Product Change Notification / SYST-22PIGS506

ERRATA - PIC32MK GPK/MCM Family Silicon Errata

PIC32MK General Purpose and Motor Control (GPK/MCM) with CAN FD Family Silicon Errata and Data Sheet Clarifications

2.2.2 VBUS pin

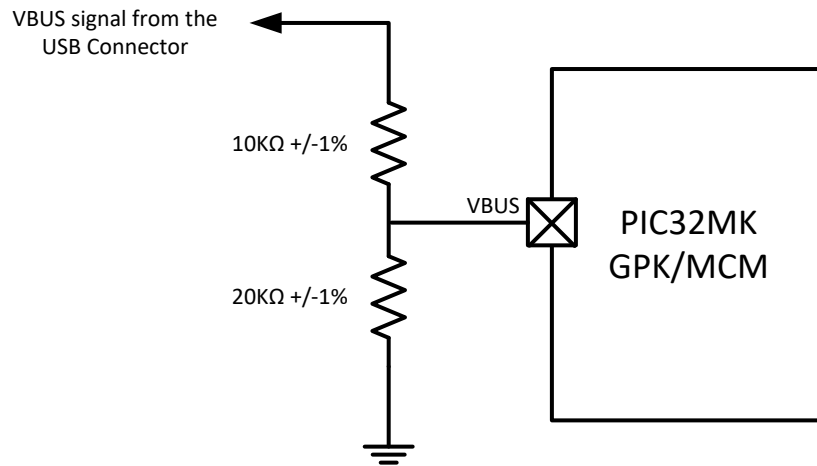
The VBUS pin is not 5V tolerant.

Connect an external voltage divider as shown in the following figure:
